Access Compliance Report

Public Rights-of-Way

Intersection ID: 10034489	Main Street: PINEBURR_RD	Cross Street: N/A	Location: SE
ADA ID: 69C82D816952	Ramp Type: BlendTrans2	Initial Pass/Fail: Fail	Overall Compliance: No
Severity Score: 12.5			
Codes/Mitigation Info/Possible Solution		Field Measurements/Component Compliance

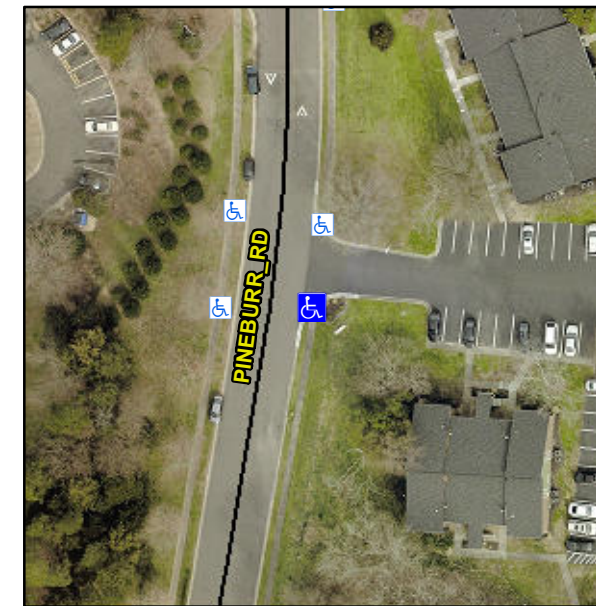
Not Found, R304.5.3

Compliance	Description	Data	Compliance	Description	Data
N/A	Ramp Length (in)	39.0	Yes	BlendTrans Slope (%)	2.4
Yes	Ramp Width (in)	48.0	No	BlendTrans XSlope (%)	5.1
N/A	Flare Type LT	N/A	N/A	Flare Type RT	N/A
N/A	Flare Slope LT (%)	N/A	N/A	Flare Slope RT (%)	N/A
N/A	Flare Traversable LT?	N/A	N/A	Flare Traversable RT?	N/A
N/A	Landing Length (in)	N/A	N/A	DWS Provided?	N/A
N/A	Landing Width (in)	N/A	N/A	DWS Contrast?	N/A
N/A	Landing Slope (%)	N/A	N/A	DWS Length (in)	N/A
N/A	Landing X Slope (%)	N/A	N/A	DWS Full Width?	N/A
N/A	Landing Curb? (Y/N)	N/A	N/A	DWS Offset (in)	N/A
N/A	Shared Landing?	N/A			
N/A	Gutter Ponding?	N/A	N/A	Gutter Slope (%)	N/A
N/A	Gutter Lip Ht (in)	N/A	N/A	Gutter X Slope (%)	N/A
N/A	Painted X Walk1?	No	N/A	Painted X Walk2?	No
	X Walk 1 Direction	To N		X Walk 2 Direction	To W
	X Walk 1 Width (in)	N/A		X Walk 2 Width (in)	N/A
	X Walk 1 Slope (%)	6.9		X Walk 2 Slope (%)	4.5
	X Walk 1 X Slope (%)	0.1		X Walk 2 X Slope (%)	6.3

N/A	Ramp inside XWalk1?	N/A	N/A	Ramp inside XWalk2?	N/A
	Road Slope (%)	4.5		Clear Space?	N/A
	Road X Slope (%)	7.6	N/A	Clear Space to XWalk (in)	N/A
N/A	Any Obstructions?	N/A	N/A	Storm Grate/Utility Hazard?	N/A
	Obstruction Type			Storm Grate/Utility Type	
		N/A			N/A
			Yes	Surface Condition? (G/P)	Good
			No	Curb Slope (%)	11.4

Remove & Replace Curb Ramp With Two New Directional Ramps or Equivalent.
